BURLINGTON DEVELOPMENT REVIEW BOARD Tuesday November 20th, 2018, 5:00 PM Contois Auditorium, City Hall, 149 Church St, Burlington, VT AGENDA

1. 19-0326CA; 121 Crescent Beach Drive AND 19-0367CA; 133 Crescent Beach Drive (RL-W, Ward 4N) Crescent Beach Drive Association

2. 19-0355CA; 441 Shelburne St (RM, Ward 5S) 441 Shelburne Road, LLC

RICHARDSON MULTIFAMILY HOUSING

SITE LIGHTING
PLAN

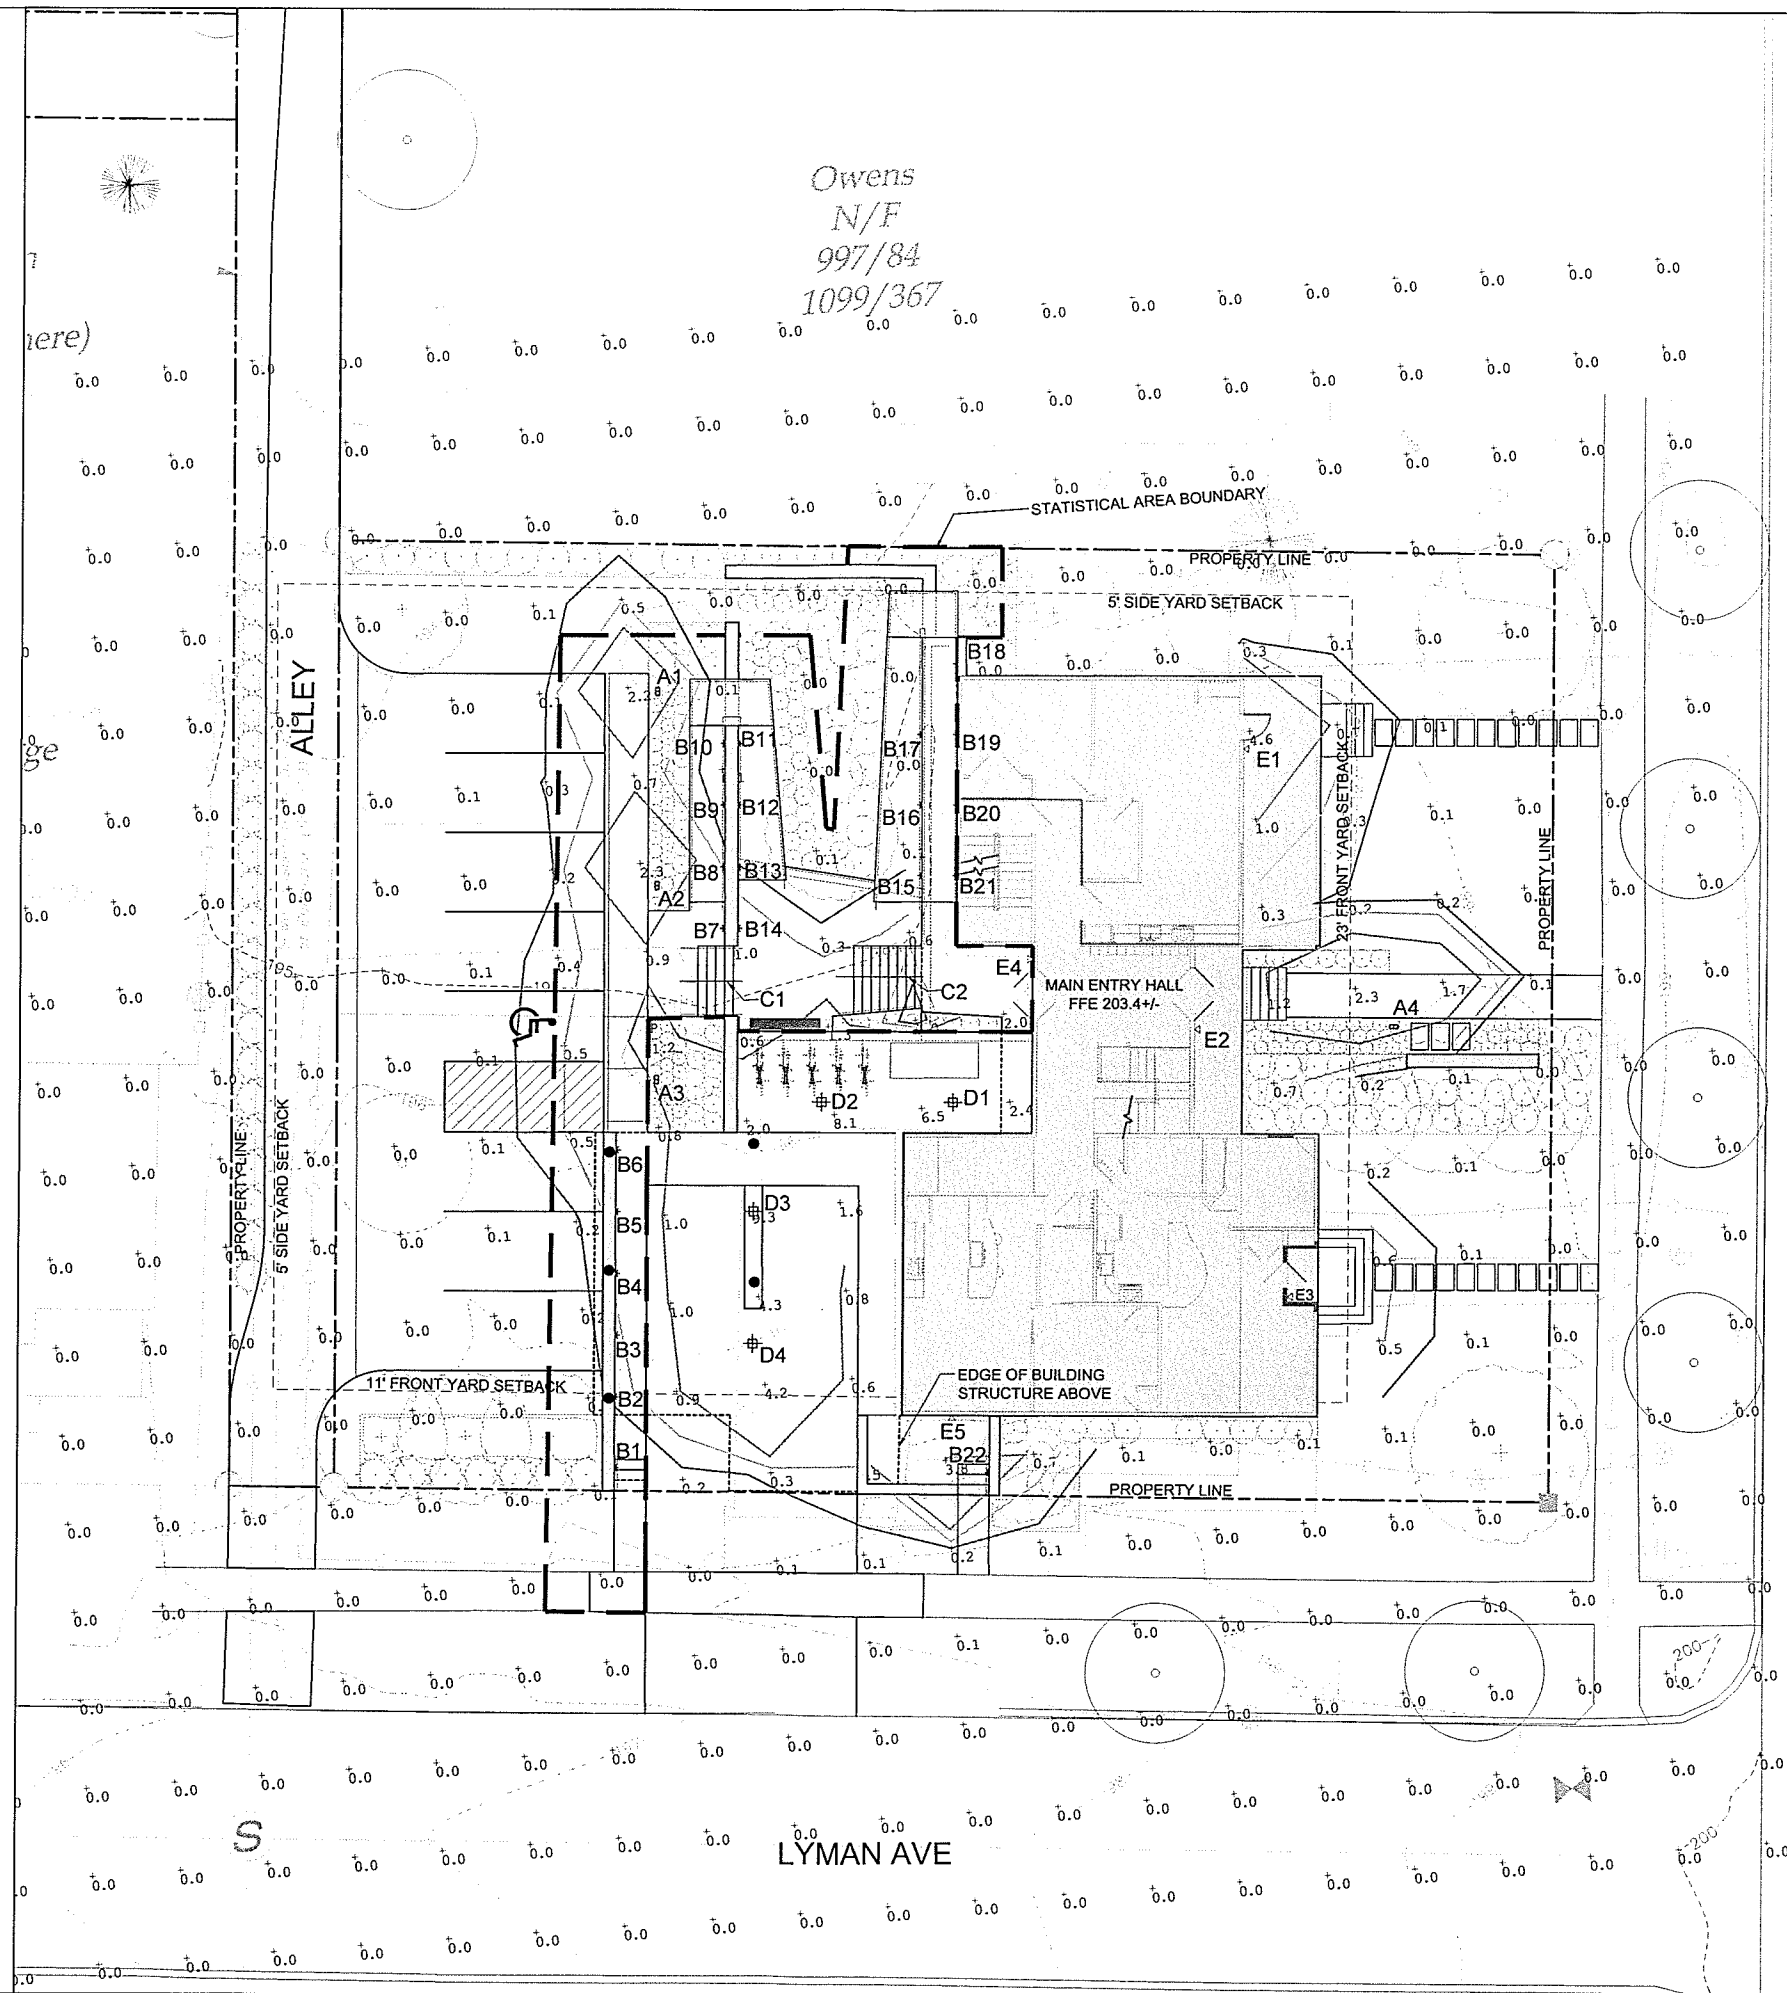
A photometric plan and associated lighting fixture cut sheets have been provided. Illumination levels are acceptable for all environments – walkways, entries, and the under-building parking. No lighting of the surface parking is proposed, although, adjacent walkways will be illuminated. Proposed light fixtures are acceptable and include cutoff and/or low level illumination fixtures. **(Affirmative finding)**
